From: karen Buckingham
Sent: 4/03/2025 1:43:57 PM
To: Claire Ryan; Council Northernbeaches Mailbox
Cc: [REDACTED] Mitchell Hale
Subject: Objection letter prepared on behalf of owners of Unit 2 - Re: DA2024/1835 - 33-35 Fairlight Street and 10-12 Clifford Avenue, Fairlight
Attachments: Unit 2 - Objection letter - DA20241835- 33-35 fairlight st and 10-12 Clifford Avenue, Fairlight.pdf;

**Submission with regard to Development Application DA2024/1835
Demolition works and construction of a residential flat building
33-35 Fairlight Street and 10-12 Clifford Avenue, Fairlight NSW**

Figure 2 –Non-compliant minimum separation distance of less than 12 metres between habitable rooms/balconies

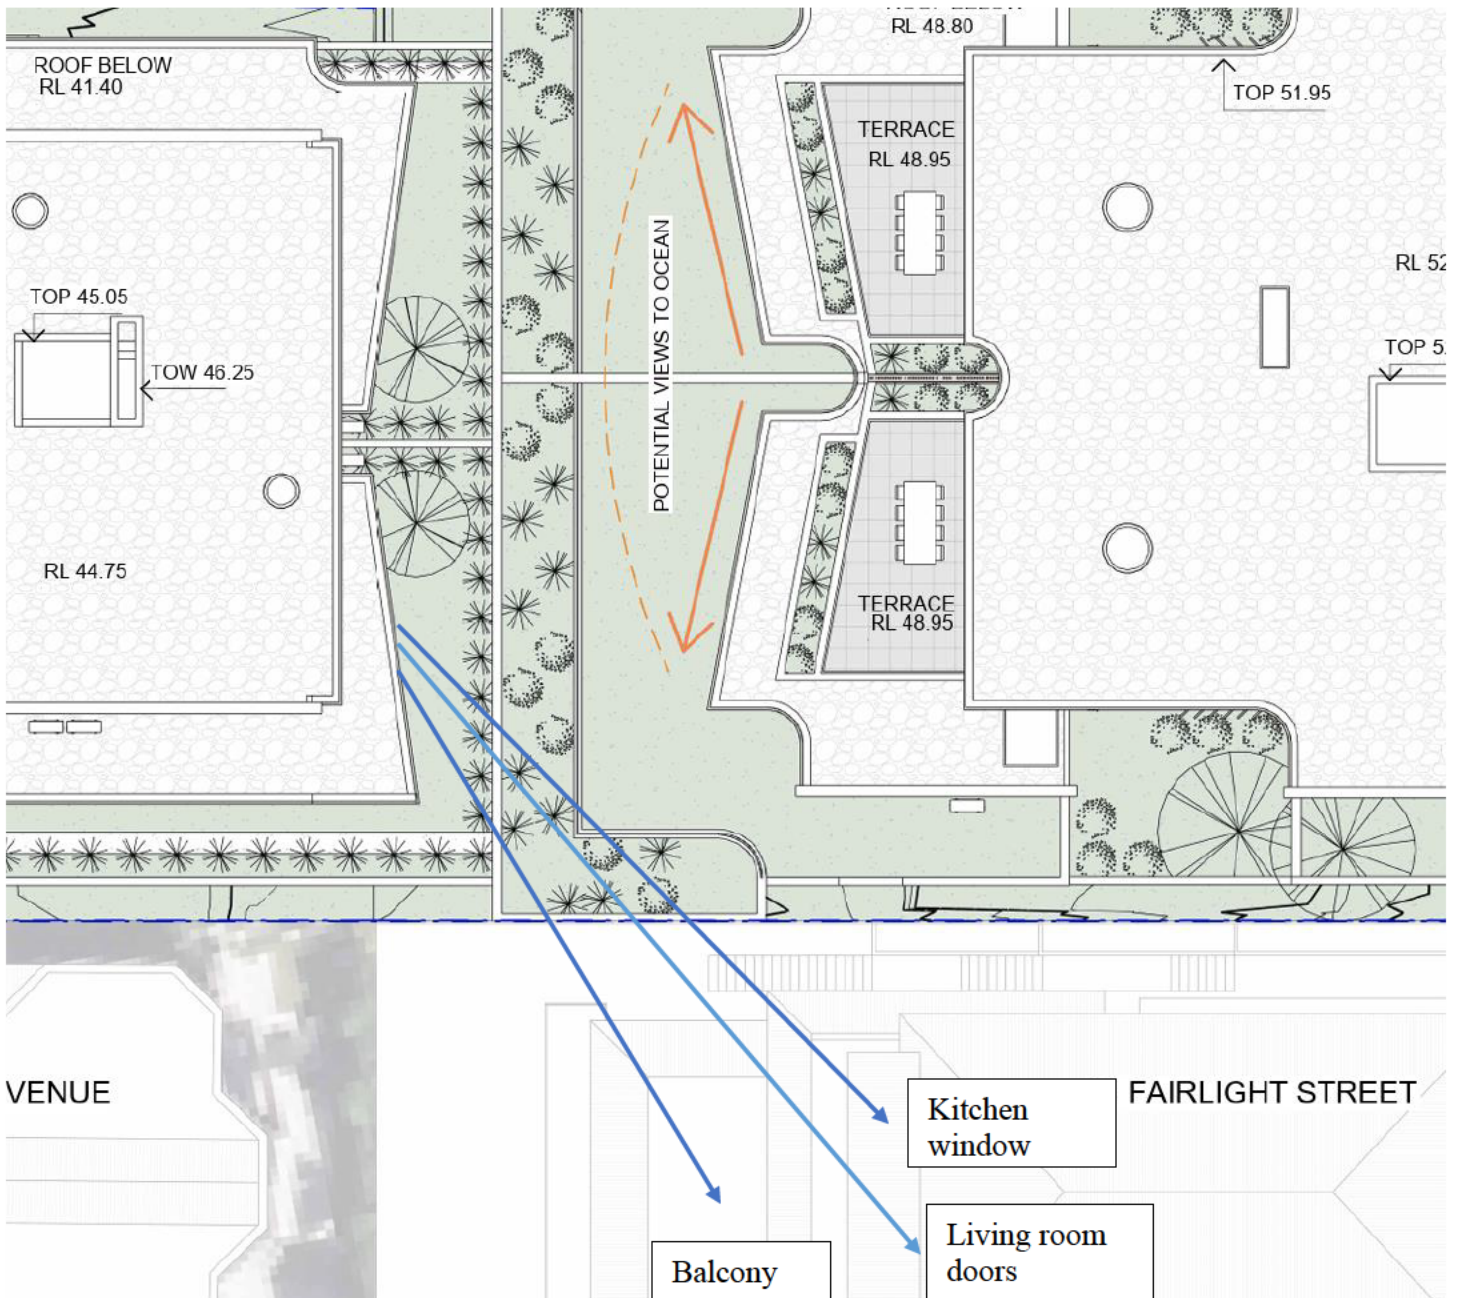
The submitted plans show that adequate separation distance has not been achieved from the western elevation to the eastern elevation of my client's property, or the windows serving the northern elevation of the Clifford Avenue block and terraces, courtyards and windows southern elevation of the Fairlight units. This is discussed further under the Privacy concerns.

The proposed development does not achieve the minimum building separation distances as required under the ADG, 3F - Building separation and by virtue of this, fails to meet the standards of the Housing SEPP.

Figure 2 of this objection letter shows the location of balconies, terraces and windows in close proximity and directly overlooking, at close proximity (less than 9 metres) from my clients private indoor and outdoor areas.
